Re: First Five Year Review for the former Davisville Naval Construction Battalion Center, North
Kingstown, RI

Re: "First Five-Year Review Report for Former Naval Construction Battalion Center (NCBC) Davisville, North Kingston, Rhode Island", dated February 2003

EFANE
FIVE-YEAR REVIEW REPORT
FORMER NBC DAVISVILLE FACILITY
NORTH KINGSTOWN, RHODE ISLAND

FIGURE 1

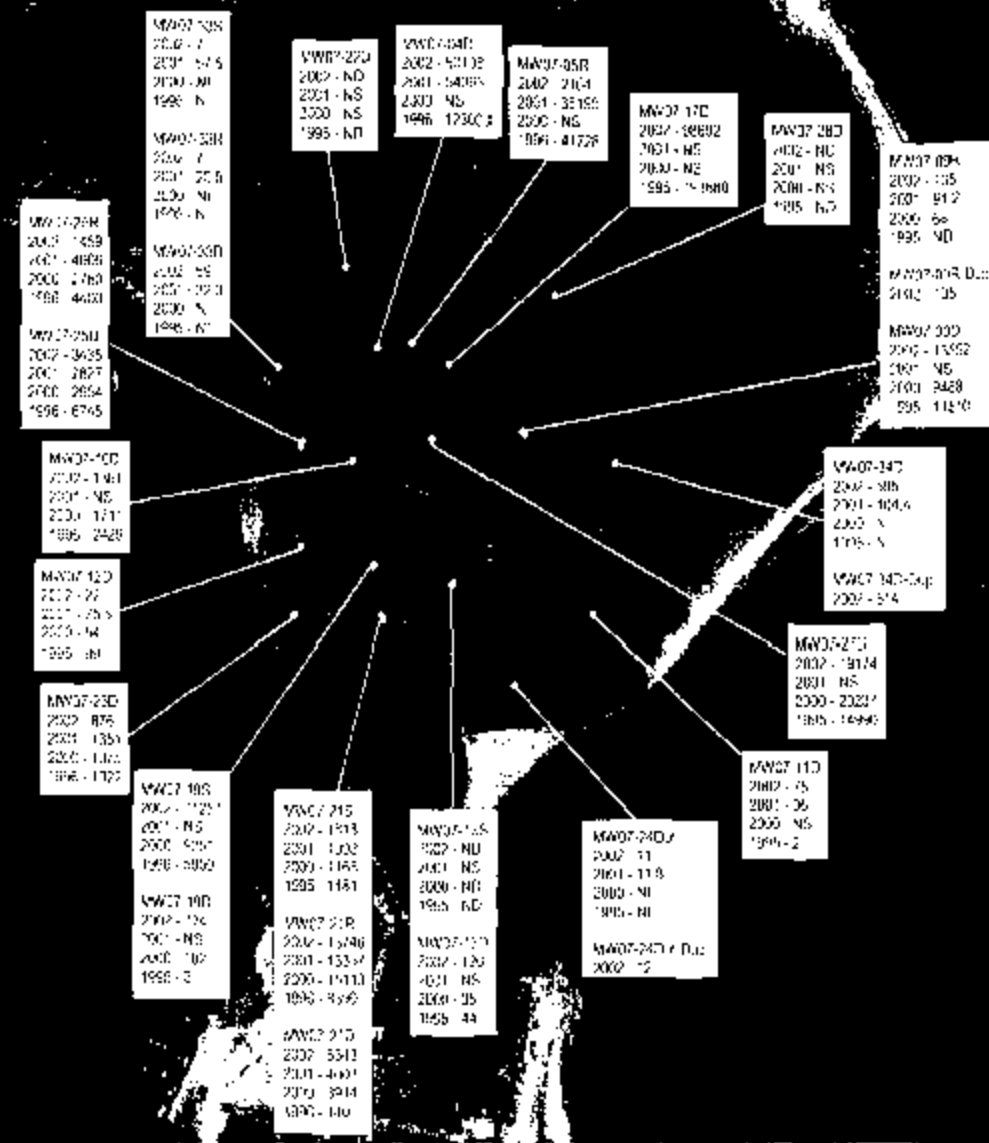
Comment 7: Figures -- Please provide Figures 1 through 5. They were not included in the submission.
